PUBLIC HEARING/WORKING SESSION II MEMORANDUM

182-184 California St.

To:	Jennifer Caira, Chief Planner City of Newton	Date:	December 21, 2018
From:	Sam Offei-Addo, PE, PTOE Knowles Spofford, EIT	Proj. No.	28402.01
Re:	Transportation Peer Review

To:	Jennifer Ciara, Chief Planner City of Newton	Date:	January 22, 2019
From:	Sam Offei-Addo, P.E. Knowles Spofford, EIT	Proj. No.	28402.01
Re:	Transportation Peer Review – Response to Comments

Garage Turning Movements
La@CA
182-184 California Street
Newton, MA

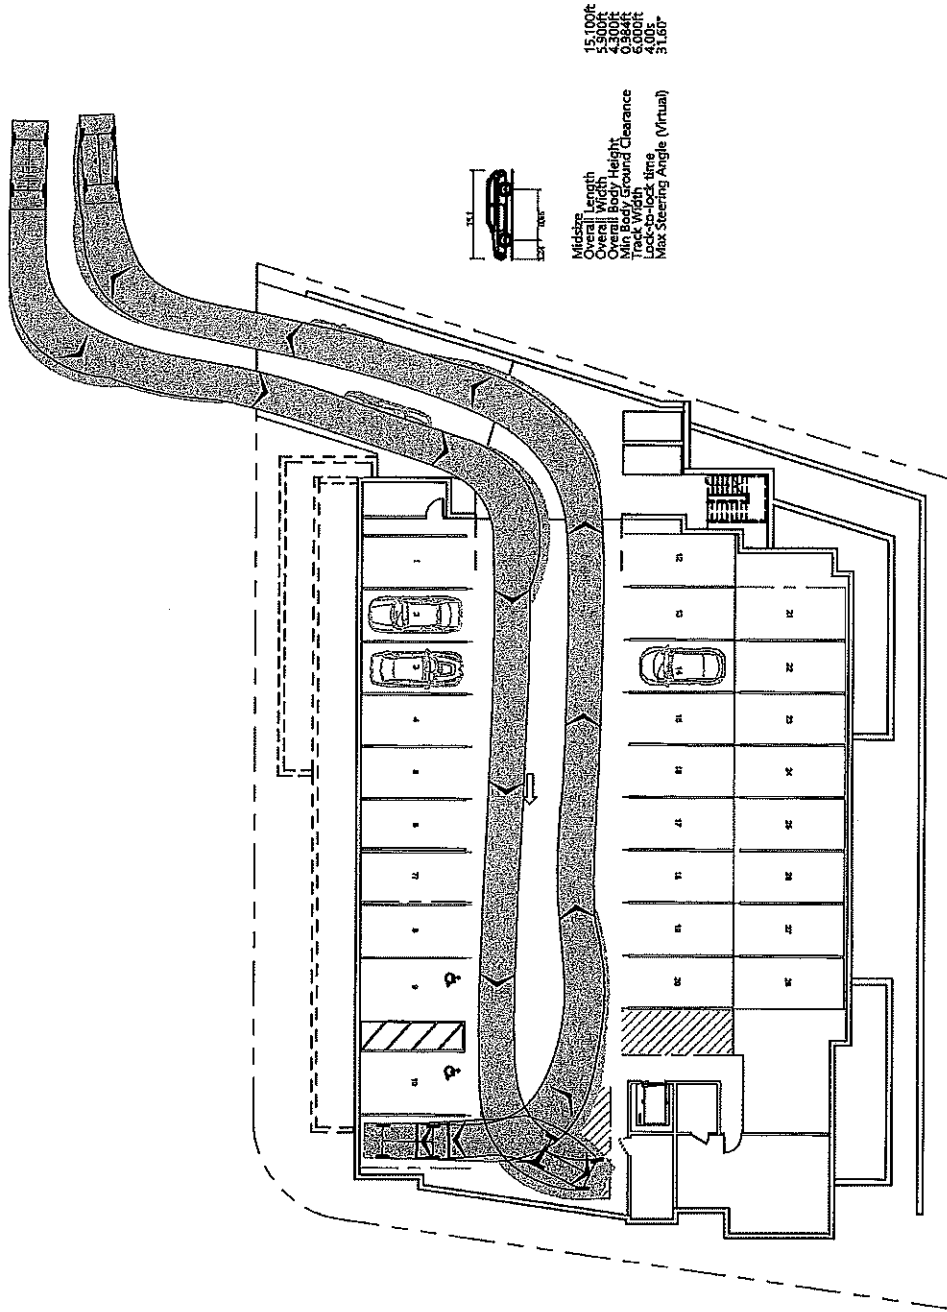
14. In the revised plan sheet displaying the basement parking, the site driveway appears to show that vehicles would enter and exit the garage at a skewed angle. Please provide a turning template showing that this angle can be handled by turning vehicles.

#14: As requested, VHB has provided a turning template showing that midsize vehicles entering and exiting the site will be able to handle the skewed angle of the site driveway. BSC has no additional comments.
